H. B. ROBINSON STEAM ELECTRIC PLANT, UNIT NO. 2
DOCKET NO. 50-261
LICENSE NO. DPR-23
IE BULLETIN 80-11,
MASONRY WALL DESIGN

As requested by your letter dated October 4, 1982, Carolina Power & Light Company (CP&L) has completed the response to your request for additional information regarding IE Bulletin 80-11, Masonry Wall Design, for the H. B. Robinson Steam Electric Plant Unit No. 2 (HBR2).

CONCRETE MASONRY WALLS
RESOLUTION OF NRC QUESTIONS
ON IE BULLETIN 80-11

B.9

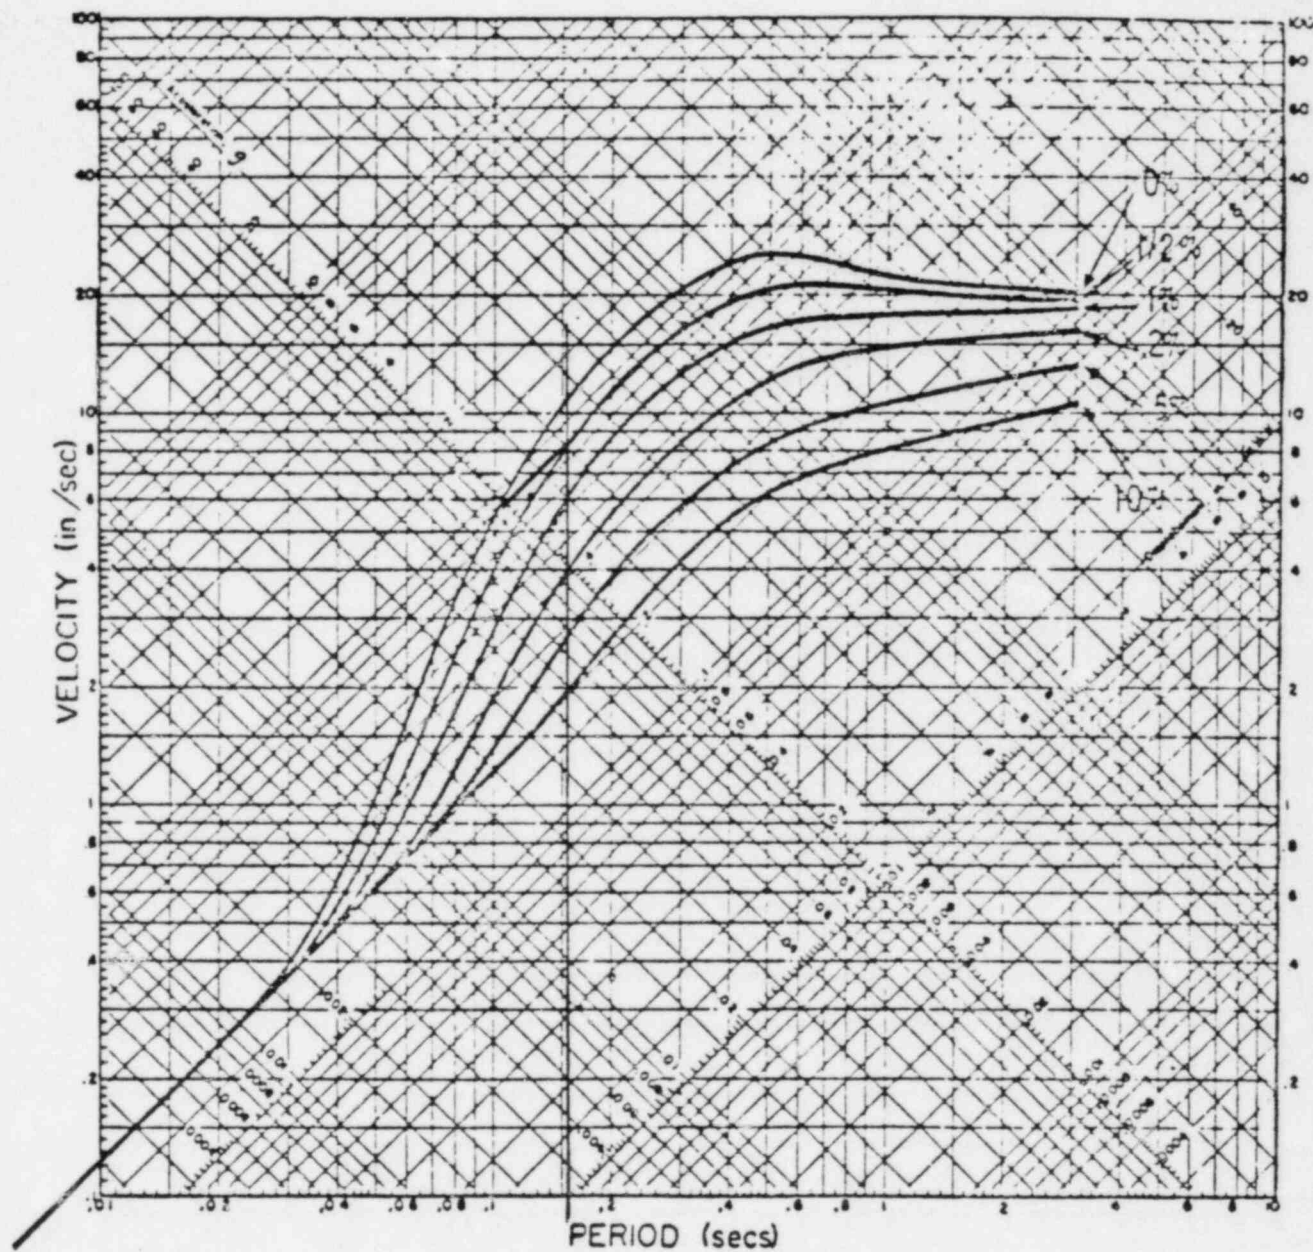
NRC Comment 10: Explain how seismic analysis was performed. Clarify whether acceleration values were selected from appropriate floor response spectrum. If not, provide justification and indicate whether the method used is consistent with the FSAR requirements.

Ebasco Response: An equivalent static analysis was performed for each wall. The analyses used a horizontal seismic acceleration factor of 0.2g, combined linearly with a vertical seismic acceleration of $2/3 \times \text{Horizontal} = 0.134g$.

From the seismic data in Appendix B of this report, we see that the accelerations from the appropriate floor response spectrum are (by using the NRC suggested damping factors specified in Regulatory Guide 1.61) lower than the assumed accelerations used in the analyses for the Fuel Handling Building and the Reactor Auxiliary Building.

- A. Reactor Auxiliary Building
 - 1. Operating Basis Earthquake-OBE (10% G)
at NRC suggested 4% damping, $g = 0.13$
 - 2. Design Basis Earthquake-DBE (20% G)
at NRC suggested 7% damping, $g = 0.18$

1. Operating Basis Earthquake-OBE (10% G)
at NRC suggested 4% damping, $g = 0.12$
2. Design Basis Earthquake-DBE (20% G)
at NRC suggested 7% damping, $g = 0.18$

1. Operating Basis Earthquake-OBE (10% G)
at NRC suggested 4% damping, $g = 0.17$
2. Design Basis Earthquake-DBE (20% G)
at NRC suggested 7% damping, $g = 0.25$

These horizontal accelerations (and associated vertical accelerations) are greater than the values used in the analysis of Wall 6. A review of the analysis of Wall 6 (included as a sample calculation in Appendix A) reveals that the designed modifications are capable of withstanding these higher acceleration values.
